LaSalle County Station

**Pre-Application Meeting
License Amendment Request
Ganged Rod Drive Capability**

**Ultimate Heat Sink
Regulatory Resolution and
Optimum Approach for Submittal of
License Amendment Request**

Simplified Circulating Water (CW) System

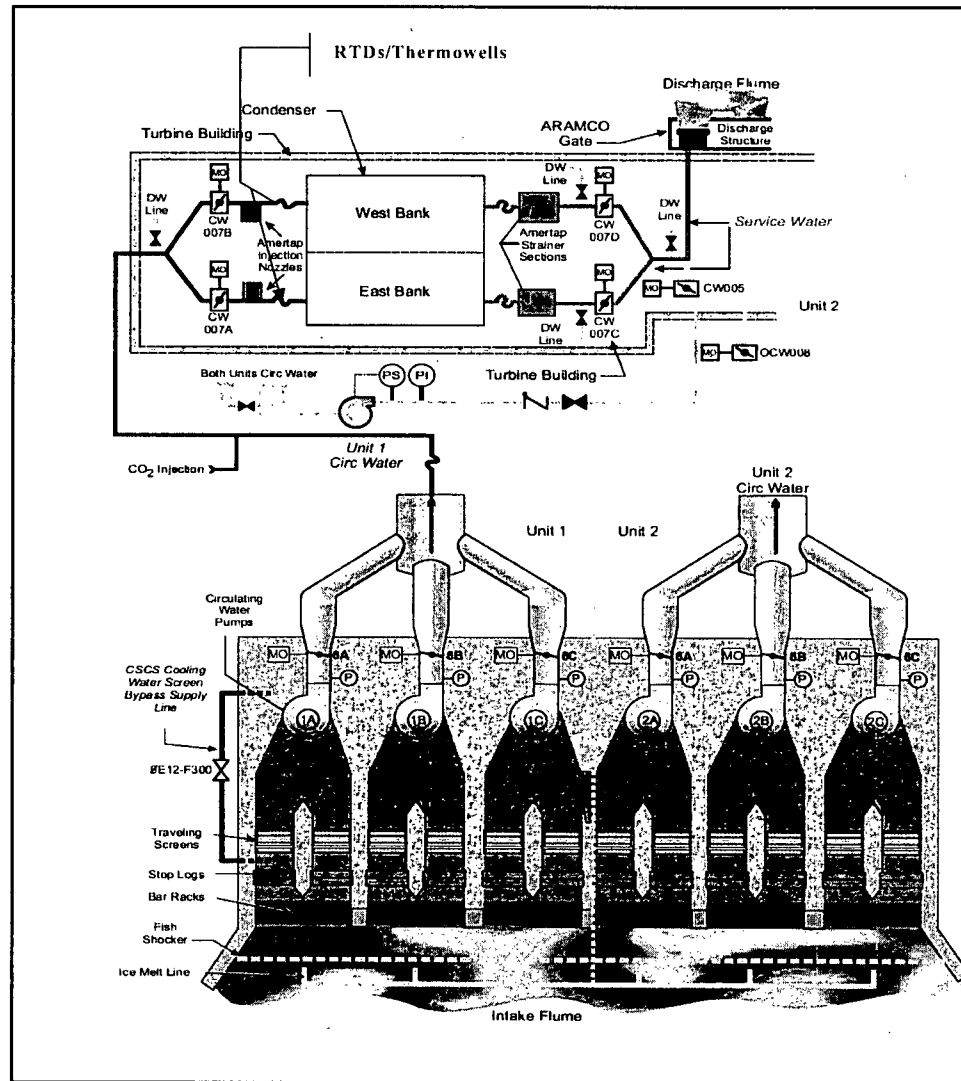
- “the TS modification itself does not adequately address single-unit operation (if only one unit is operating the lack of flow to the other unit could cause the temperature measurements associated with that unit to become non-representative of the UHS temperature)”
 - The Circulating Water (CW) temperature instrumentation indication loop(s) are of an equivalent design
 - The replacement instrumentation used to measure the UHS temperature is non-safety-related, installed and fully functional
 - The method and procedures used to determine UHS are unchanged
 - The CW temperature of the installed RTDs on either unit is representative of the UHS temperature with a CW pump running
 - If the unit does not have a CW pump in operation, the surveillance procedure directs the CW temperature to be recorded from a unit that does have a CW pump in operation
